PRODUCT CHANGE NOTIFICATION

Bourns® Model SRN8040 Series Semi-shielded Power Inductors

Change to Inductor Core Design and Wire Diameter

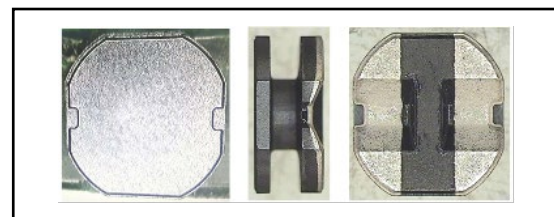
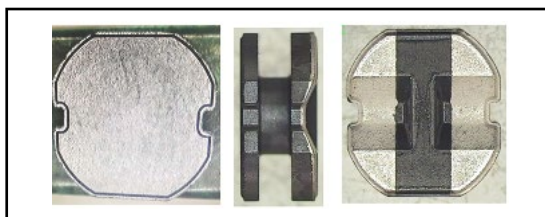
Riverside, California – August 13, 2021 – Effective February 12, 2022, Bourns will change the inductor core design of the [Model SRN8040 Series Semi-shielded Power Inductors](#). The modified inductor core will be comprised of a thicker top flange, removal of wire channels on the top flange and a reduced winding length. These modifications will strengthen the core structure and reduce the risk of a core crack.
